Access Compliance Report

Public Rights-of-Way

(Curb Ramps)

Intersection ID: N/A	Main Street: SOUTHMORE_DR	Cross Street: HOUSTON_FIELD_CT	Location: SW
ADA ID: 404B7FE85860	Ramp Type: PerpDiag	Initial Pass/Fail: Fail	Overall Compliance: No
			Severity Score: 13.75

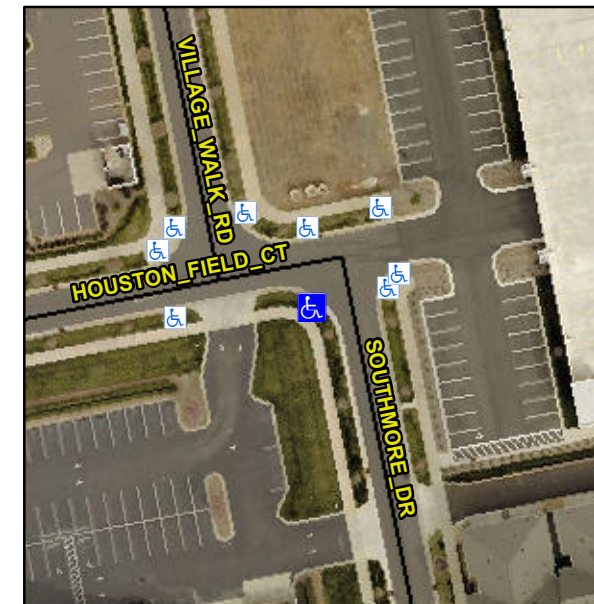
Not Found, R304.2.2, R304.5.3

Compliance	Description	Data	Compliance	Description	Data
N/A	Ramp Length (in)	96.0	No	Ramp Slope (%)	9.8
Yes	Ramp Width (in)	65.0	No	Ramp XSlope (%)	2.6
N/A	Flare Type LT	N/A	N/A	Flare Type RT	N/A
N/A	Flare Slope LT (%)	N/A	N/A	Flare Slope RT (%)	N/A
N/A	Flare Traversable LT?	N/A	N/A	Flare Traversable RT?	N/A
N/A	Landing Length (in)	N/A	N/A	DWS Provided?	N/A
N/A	Landing Width (in)	N/A	N/A	DWS Contrast?	N/A
N/A	Landing Slope (%)	N/A	N/A	DWS Length (in)	N/A
N/A	Landing X Slope (%)	N/A	N/A	DWS Full Width?	N/A
N/A	Landing Curb? (Y/N)	N/A	N/A	DWS Offset (in)	N/A
N/A	Shared Landing?	N/A			
N/A	Gutter Ponding?	N/A	N/A	Gutter Slope (%)	N/A
N/A	Gutter Lip Ht (in)	N/A	N/A	Gutter X Slope (%)	N/A
N/A	Painted X Walk1?	No	N/A	Painted X Walk2?	No
	X Walk 1 Direction	To E		X Walk 2 Direction	To N
N/A	X Walk 1 Width (in)	N/A	N/A	X Walk 2 Width (in)	N/A
	X Walk 1 Slope (%)	4.8		X Walk 2 Slope (%)	2.1
	X Walk 1 X Slope (%)	0.4		X Walk 2 X Slope (%)	5.2

Remove & Replace Curb Ramp With Two New Directional Ramps or Equivalent.
